ADDENDUM NO. 1

TOWN OF KEENE RETAINING WALL

Town of Keene, NY

August 27, 2012

TYPICAL GRAVEL ROADWAY SECTION
N.T.S.

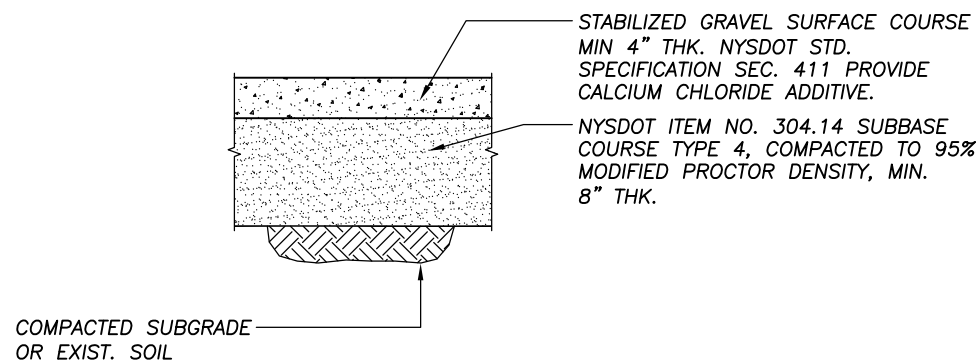
1. **Regarding Drawing C-5 Sections and Details:** DELETE the Typical Gravel Roadway Section and Typical Gravel Pavement Detail indicated and SUBSTITUTE THEREFORE the Typical Gravel Roadway Section and Typical Gravel Pavement Detail indicated on attached Drawing SK-1.
2. **Regarding Drawing N-1 General Notes, Note 6:** Attached is a copy of the permit information from the NYS Department of Environmental Conservation for reference.
